Product Change Notification / SYST-04SBWB795

ERRATA - ATtiny1614/1616/1617 Silicon Errata and Data Sheet Clarification

ATtiny1614/1616/1617

Silicon Errata and Data Sheet Clarifications

Figure 3-1. Block Diagram

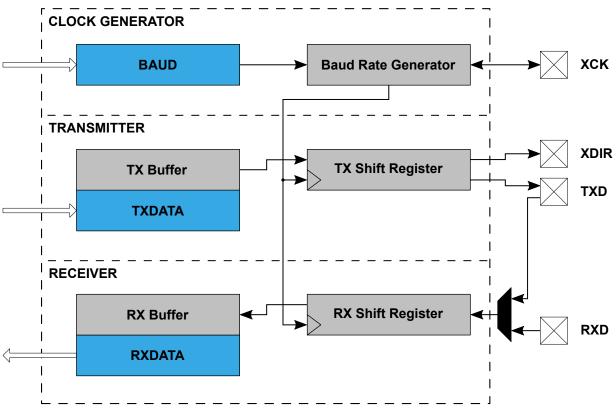
The block diagram is missing that USART TX is double-buffered from Figure 25-1 in the data sheet. The figure below shows the added **TX Buffer**.

The following text is changed in the *Overview* section:

The transmitter consists of a two-level write buffer.

The following text is changed in the *Data Transmission* section:

The data transmission is initiated by loading the **Transmit Data (USARTn.TXDATAL and USARTn.TXDATAH)** registers with the data to be sent. The data in the **Transmit Data registers are moved to the TX Buffer** once emptied and then to the Shift register once it is empty and ready to send a new frame.
